From:
To:
Cc:
Subject: RE: Phase 7 cvc request for initial clarifications [NLP-DMS.FID262297]
Date: 26 October 2018 16:00:14
Attachments:

NYM/2018/0585/CVC – Phase 7 conditions discharge

Request for initial clarifications

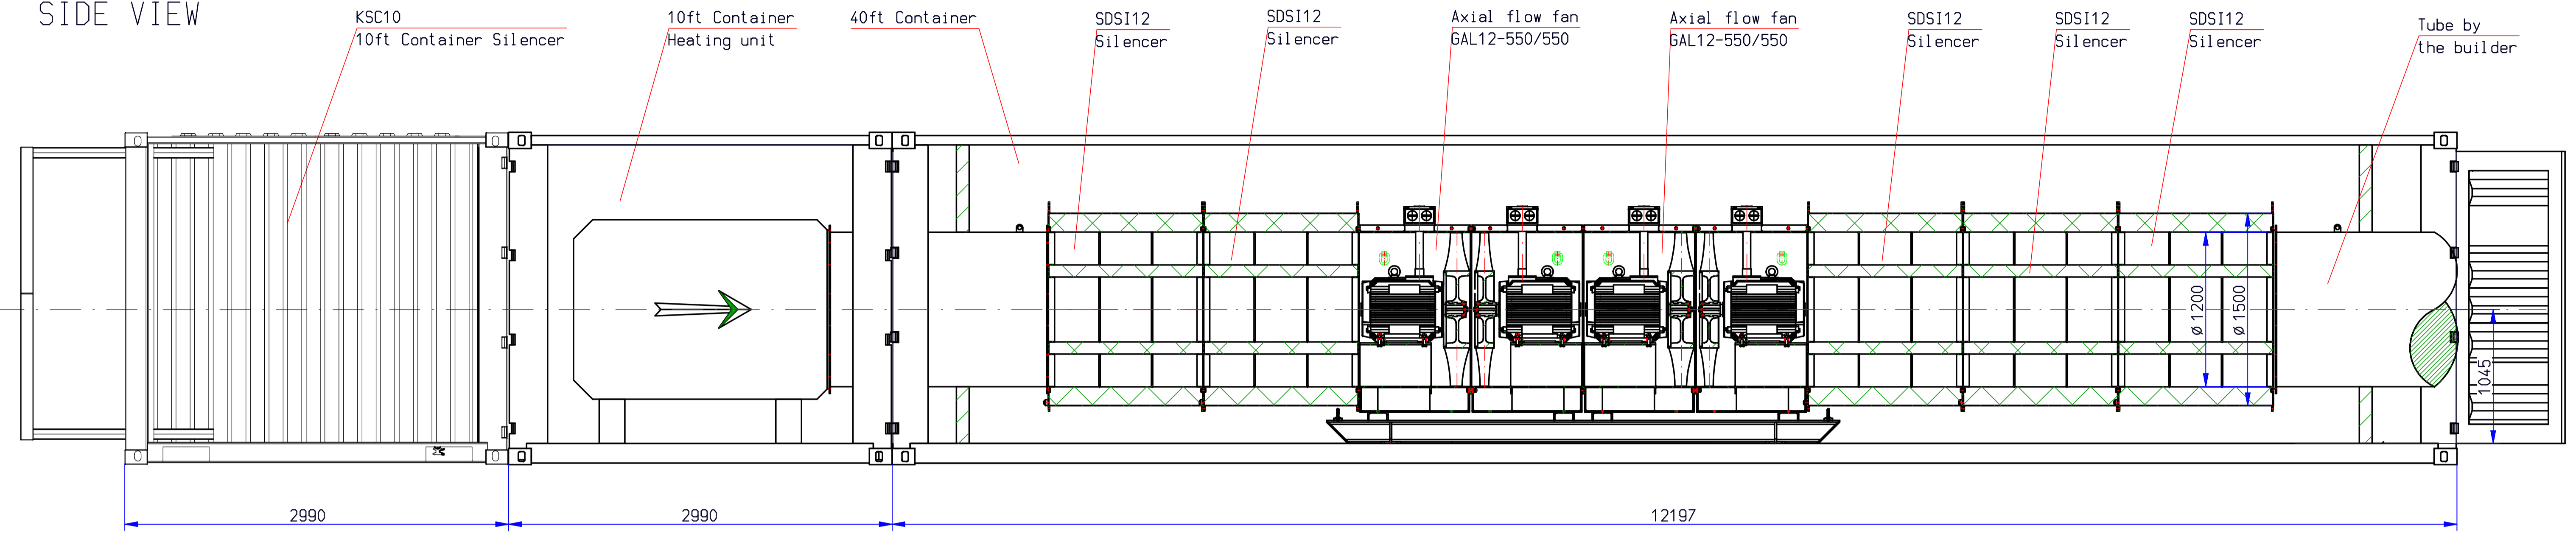
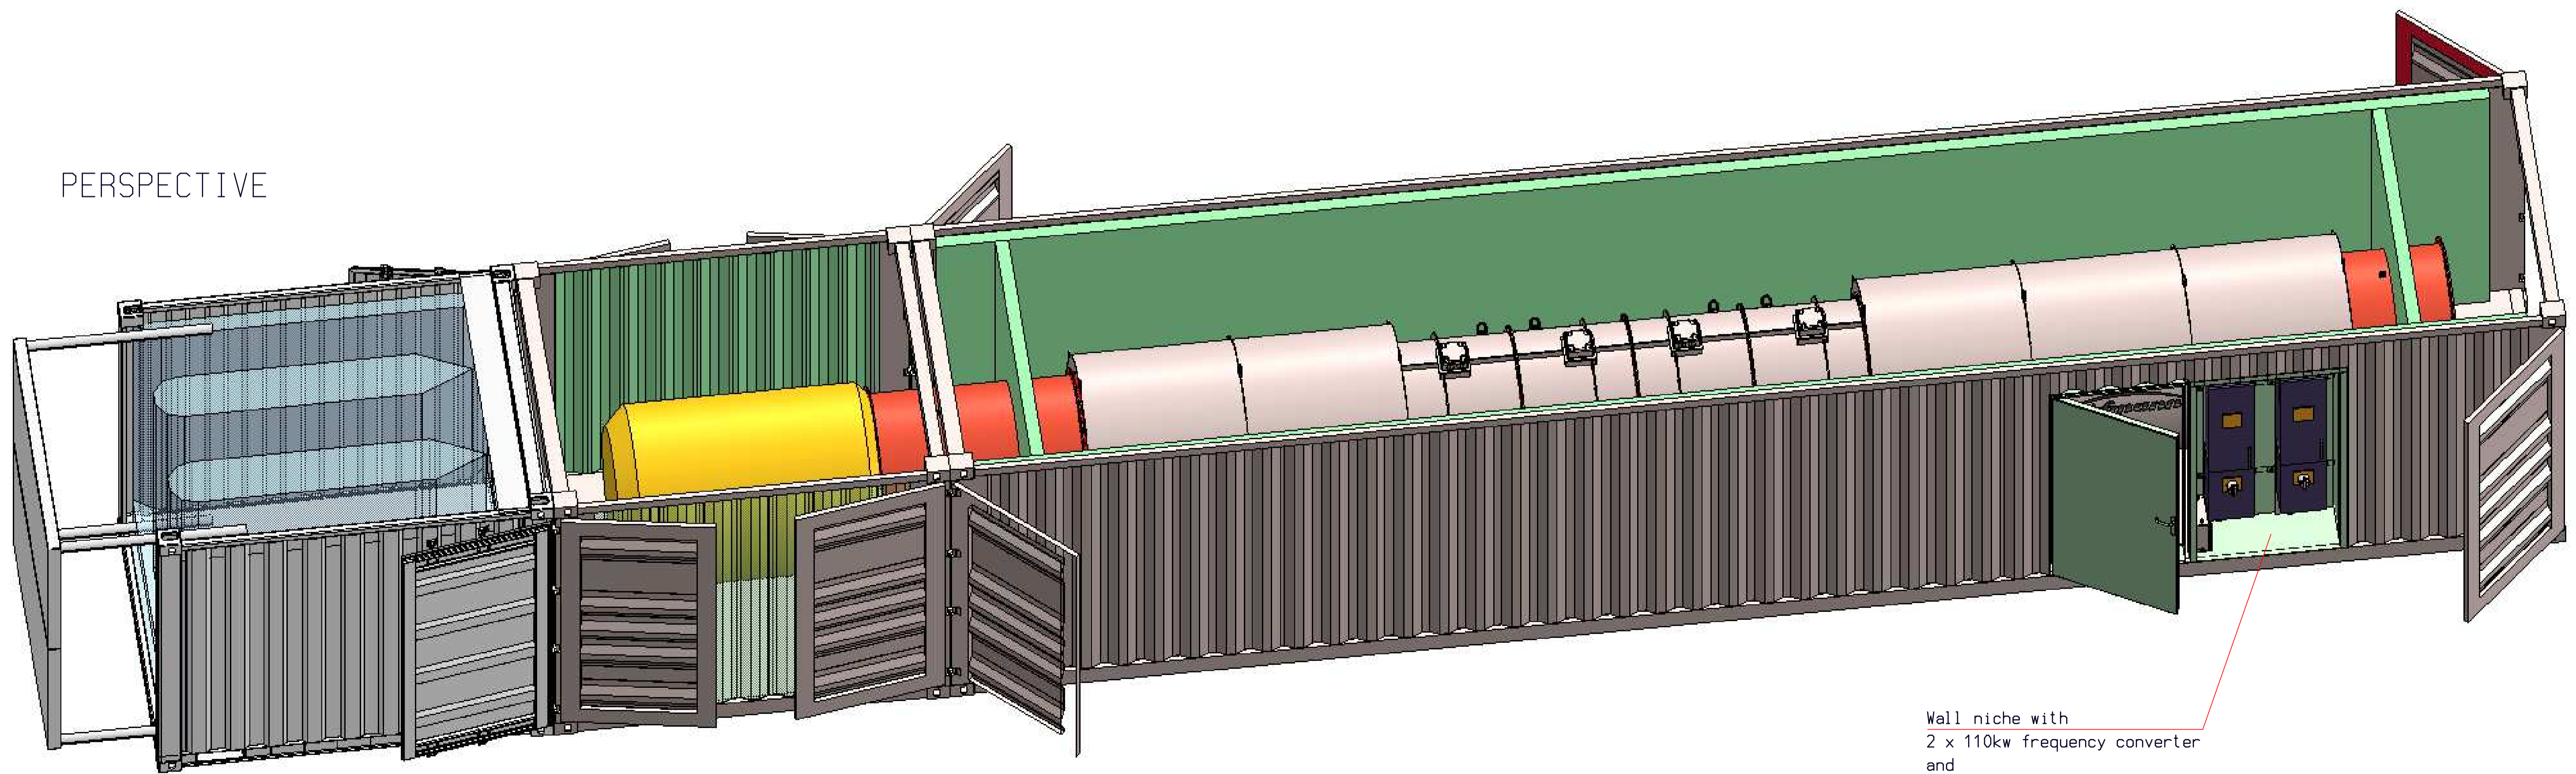
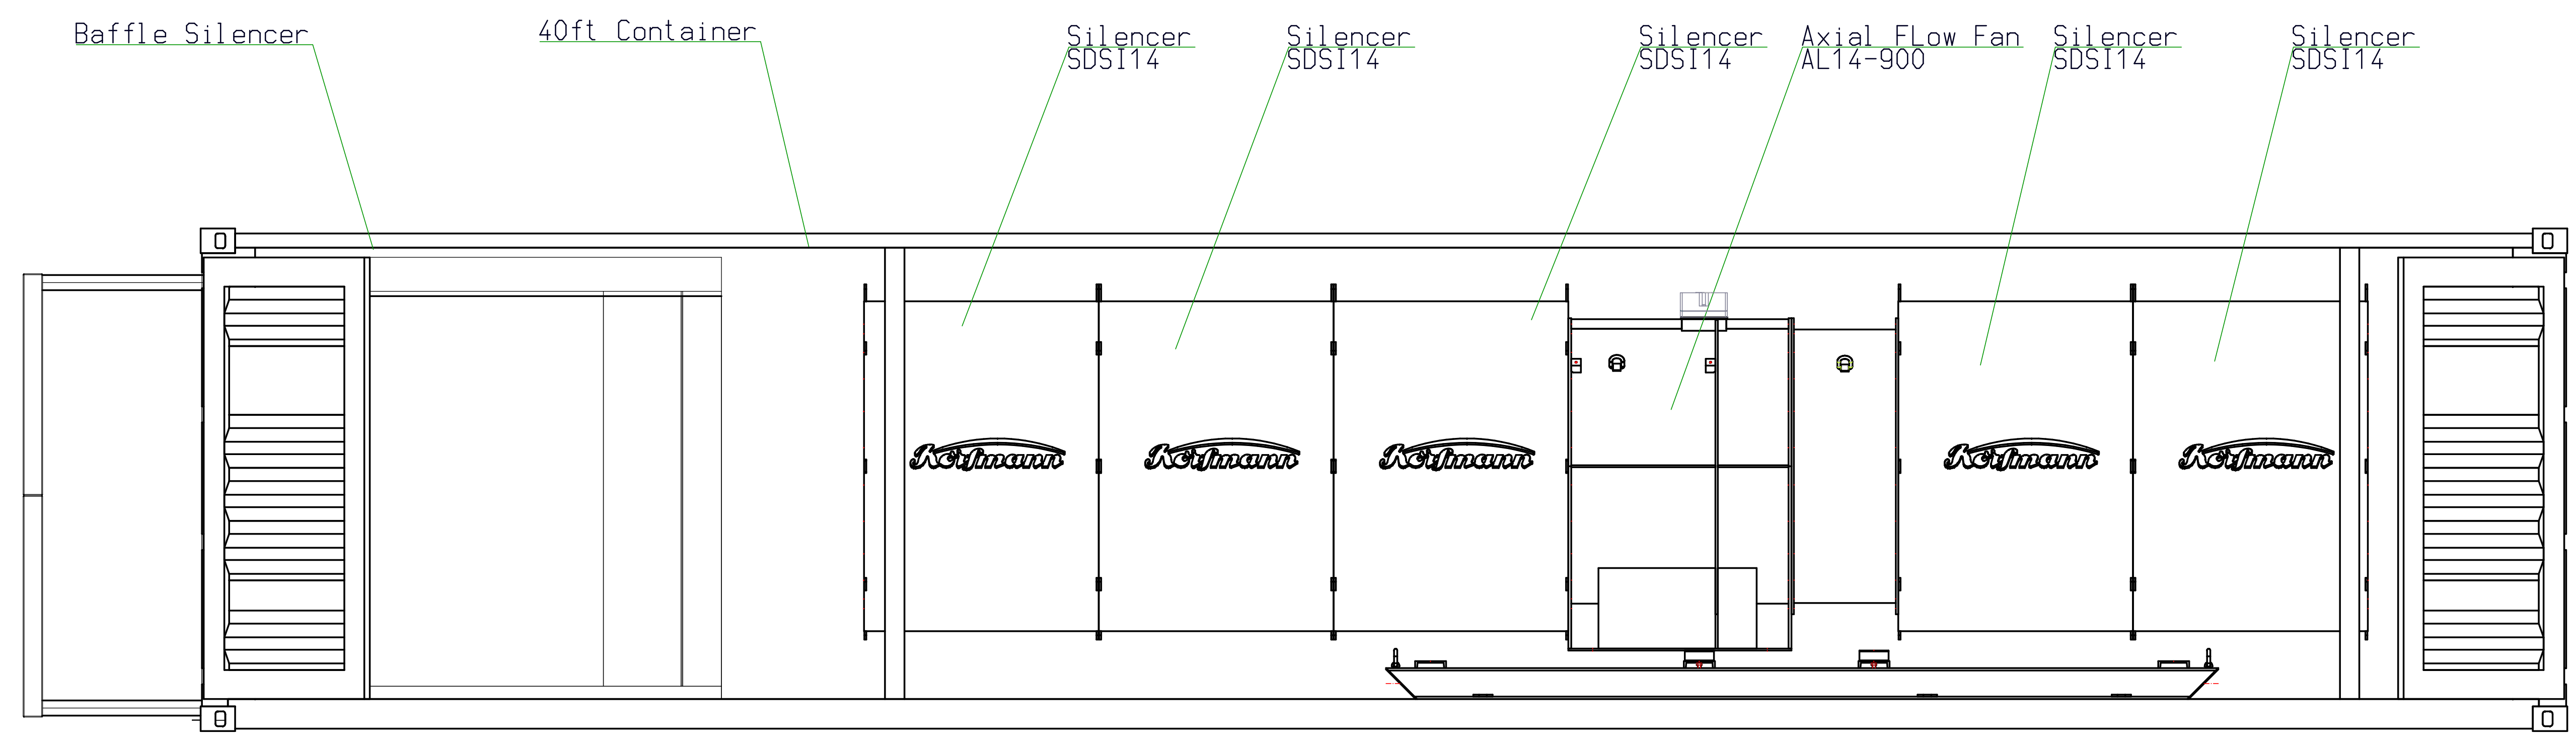
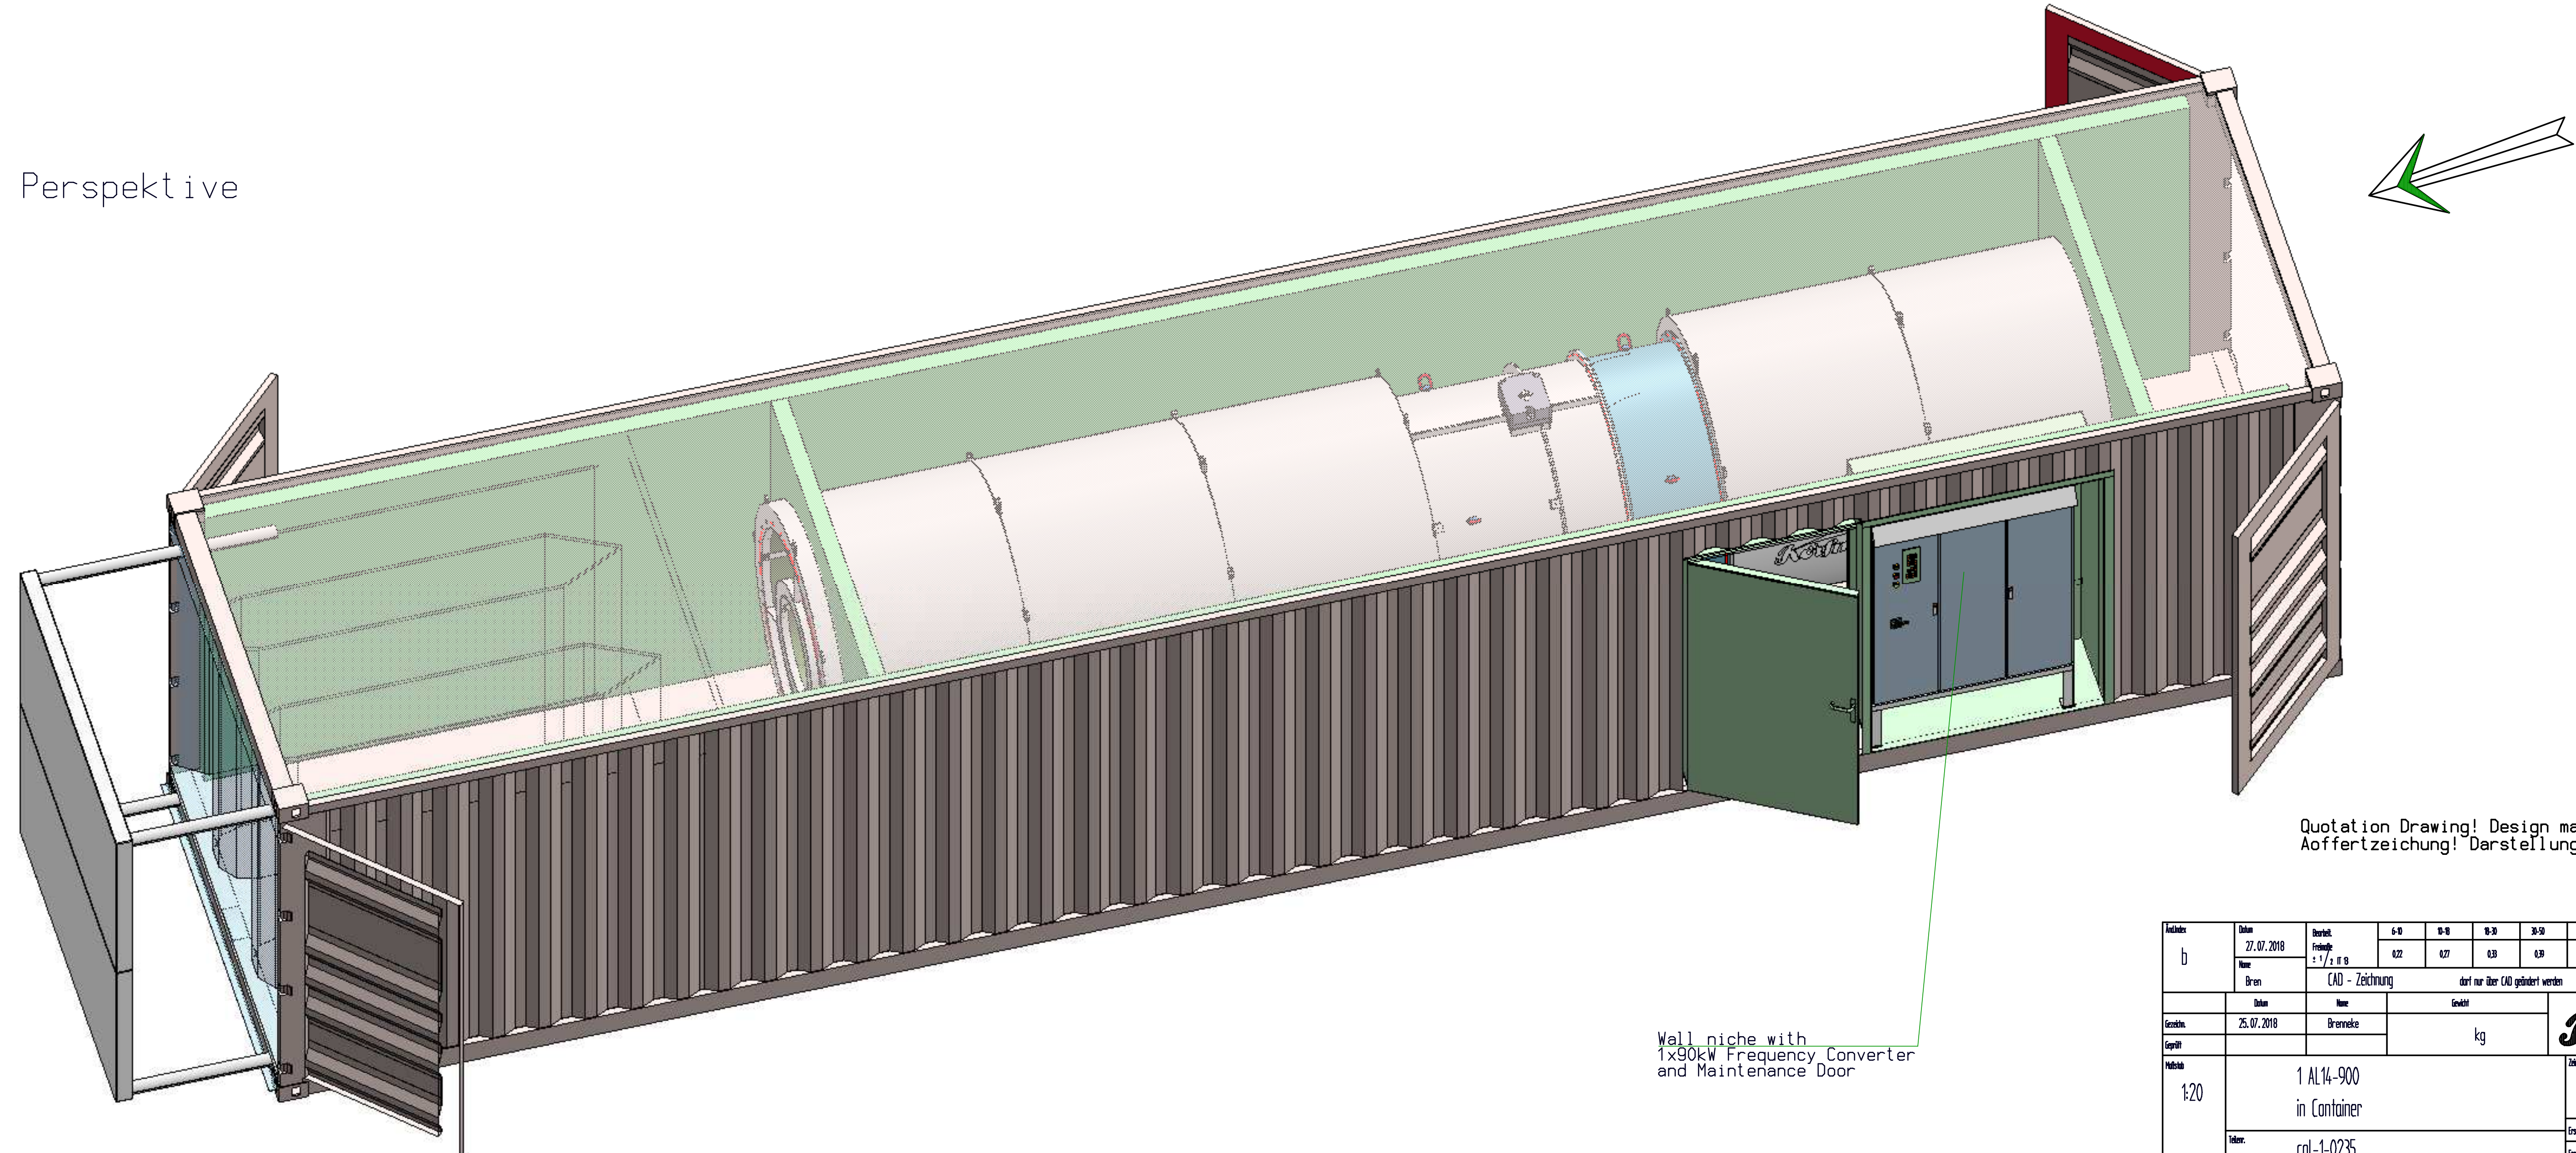
2) Drawing 40-ARI-WS-7100-CI-18-01006 also shows further proposed buildings/structures, including ventilation system structures and temporary workshops/warehouse associated with the service and production shafts. There does not appear to be any information in the submission which indicates the intended size (height) or appearance of these structures. It would be helpful if this could be provided. If it is expected that these structures would be visible to users of the adjacent B1416, it would also be helpful if a representative cross-section to illustrate this could be supplied.

Building / Structure	Drawing Numbers
MTS Temporary Workshops / Warehouse	<ul style="list-style-type: none"> • 40-DMC-WS-7219-AR-15-00001 • 40-DMC-WS-7219-GN-18-00001
MTS Ventilation Details	<ul style="list-style-type: none"> • COL-1-0233_MTS Burner Fan 2GAL12-550-550_Rev_C • COL-1-0235_Exhaust Fan_AL14-900_Rev_b
Production Shaft Temporary Winch House	See Construction Method Statement – 3.6.4
Service Shaft Winch House	
Production Shaft and Service Shaft Ventilation Details	These will be the same as those listed under the 'MTS Ventilation Details' above. They will be located within the ventilation system footprints for the Production and Service Shafts, as shown on the submitted Construction Masterplan drawing (ref. 40-ARI-WS-7100-CI-18-01005)
